We would like to thank the reviewers and editor for the generally positive feedback and constructive comments. The suggestions have been implemented in this revised manuscript, and we believe it is ready for publication. In the resubmission, new and revised text are shown in blue.

RESPONSE REVIEWER 1

Figure 5. (a) Earth-axis and (b) wind-axis coordinate systems. Both figures show a tether with 10 nodes.

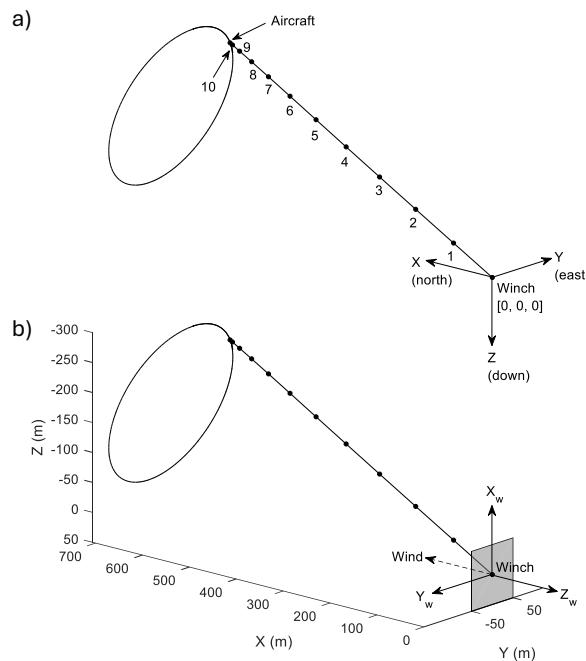
The naming of the reference frames could be improved. Instead of "primary coordinate system," I would call it a NED (north-east-down) reference frame, which is more common in the literature and more specific. Furthermore, it is not mentioned whether the "wind frame" is an inertial frame or not.

The term 'primary coordinate system' has been removed from the revision, and the section describing the coordinate system has been rewritten (lines 93-104). The wind frame is an inertial frame – this point is now stated in the revision.

We have initially considered using $[N, E, D]$ instead of $[X, Y, Z]$ to denote the aircraft's location on the flat-Earth plane. However, moving away from the XYZ sequence weakens the link between the coordinate orientation and its Euler angles $[\phi, \theta, \psi]$. Since the Euler angles on both reference frames (Earth and wind) play a crucial role in the paper's main argument, we want to make this link clear. The original notation is therefore retained: $[X, Y, Z]$ and $[\phi, \theta, \psi]$ for the aircraft's location and Euler angle on the flat-Earth plane, and $[X_w, Y_w, Z_w]$ and $[\phi_w, \theta_w, \psi_w]$ for their counterparts on the wind frame. To make the distinction between two coordinate systems clearer, we have split figure 5 into two subfigures, reproduced below.
